H. B. ROBINSON UNIT 2

Amendment No. 15
License No. DPR-23

CHANGE NO. 40 TO THE TECHNICAL SPECIFICATIONS

SAFETY EVALUATION BY THE OFFICE OF NUCLEAR REACTOR REGULATION

Figure 3.10-2 SHUTDOWN MARGIN vs BORON CONCENTRATION

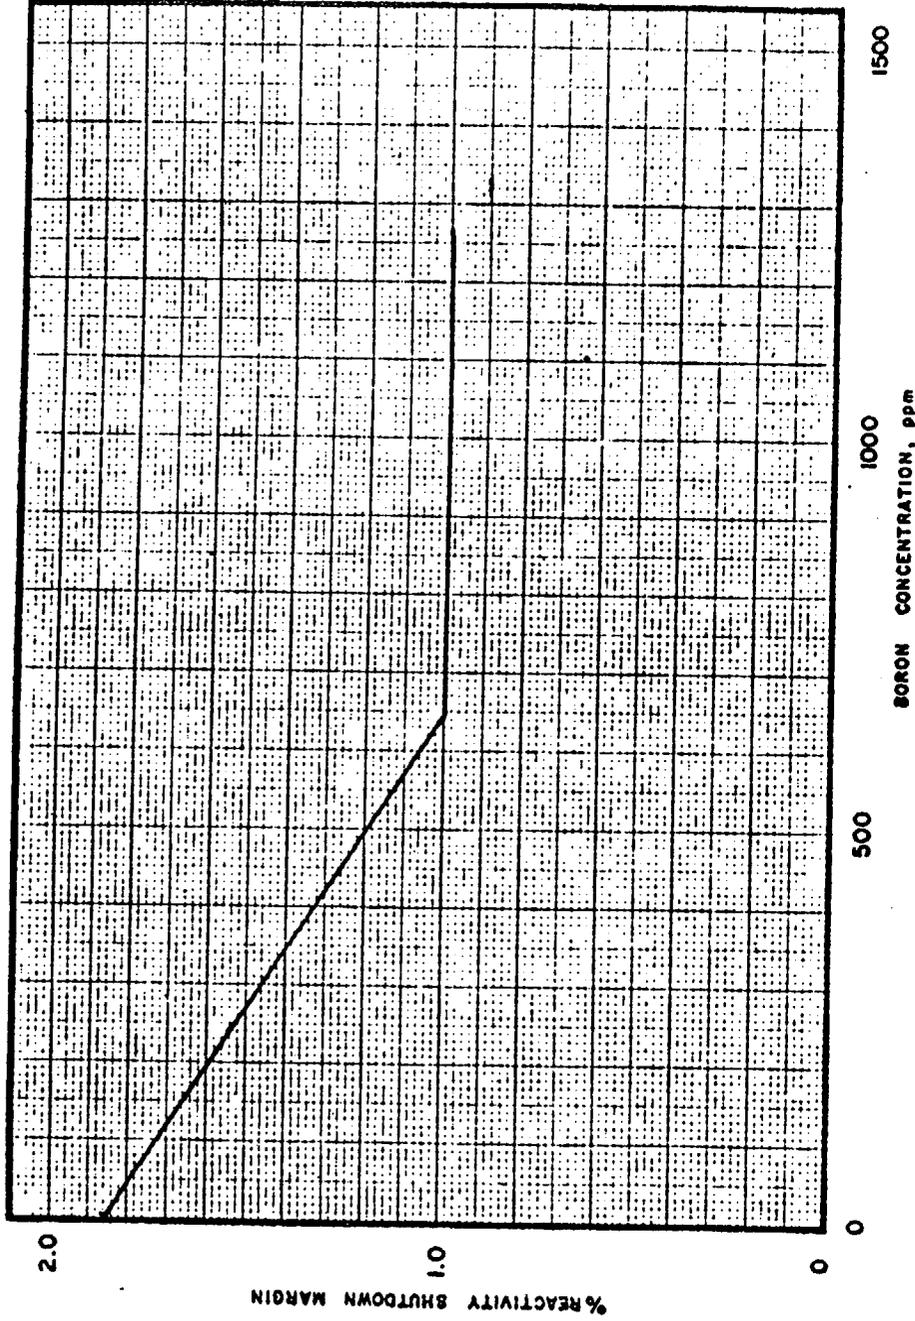
3.10.1.6 Insertion limits do not apply during physics tests or during periodic exercise of individual rods. However, the shutdown margin indicated in Figure 3.10-2 must be maintained except for the low power physics test to measure control rod worth and shutdown margin. For this test the reactor may be critical with all but one full length control rod inserted and part length rods fully withdrawn.
